UNITED STATES NUCLEAR REGULATORY COMMISSION

EXEMPTION AMENDMENT

ADDENDUM TO EXEMPTION REQUEST # 1
APPENDIX R REPORT
NORTH ANNA POWER STATION

The following changes are being made to Exemption Request # 1, Auxiliary Building - Partial Area Fire Suppression and Detection.

FIGURE NO.
1.3

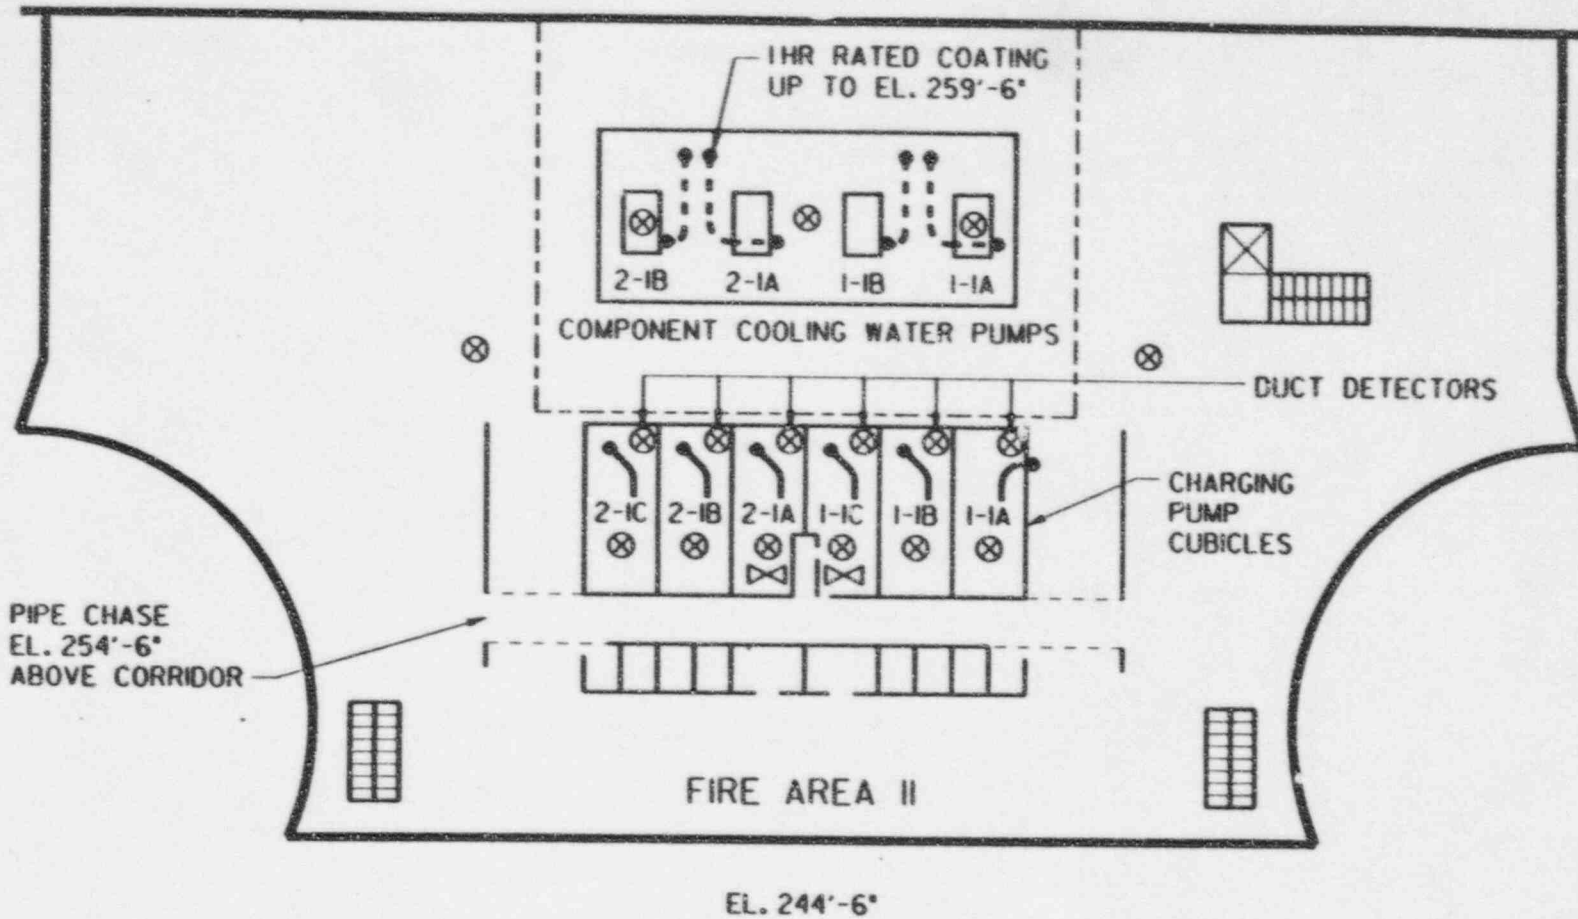
"The horizontal pipe chase is located south of the charging pump cubicles and extends along the south wall of each pump cubicle (See Figure 1.3). The pipe chase is open ended at the pipe penetration areas adjacent to the

Unit 1 and 2 Containments, and has openings into the adjacent cubicles (seal water filters, heat exchangers, ...etc.) located on the south side of the pipe chase. The vertical pipe chase is located between cubicles 2-1A and 1-1C and extends vertically to the Volume Control Tank (VCT). This vertical chase has an unsealed opening into cubicle 1-1C and is open ended at the VCT with no intermediate openings. The vertical and horizontal pipe chases are not expected to create a fire exposure to the cubicles due to the lack of combustible material in the chases. A fire in cubicle 1-1C would not be expected to enter the pipe chases due to the negligible amount of combustibles in the chases. If the fire did enter the chases, it would travel out and away from the adjacent cubicles which have penetrations sealed with metal plates."

"It is not considered credible, based on the configuration described above, for a fire in an individual charging pump cubicle to expose an adjacent cubicle or to propagate out of the cubicle. A fire in cubicle 1-1C would not be expected to enter the pipe chases due to the negligible amount of combustibles in the chases. If the fire did enter the chases, it would travel out and away from the adjacent cubicles which have penetration seals. The metal plates will provide an adequate seal against the passage of smoke and hot gasses based on the configuration and lack of combustibles in the corridor and pipe chase. It is not considered credible for a fire in the open areas of the 259 ft.-6 in. elevations to expose a charging pump (although it may affect the power feeds) or valves within a cubicle since the floor openings have dikes. It is not credible for a fire to spread from the general areas of the 244 ft.-6 in. elevation into the pipe chase due to the negligible combustible loading in the area and long travel distance from the open ends of the chase to the cubicles."

2. Figure 1-3 is replaced with the revised Figure 1-3 (attached).
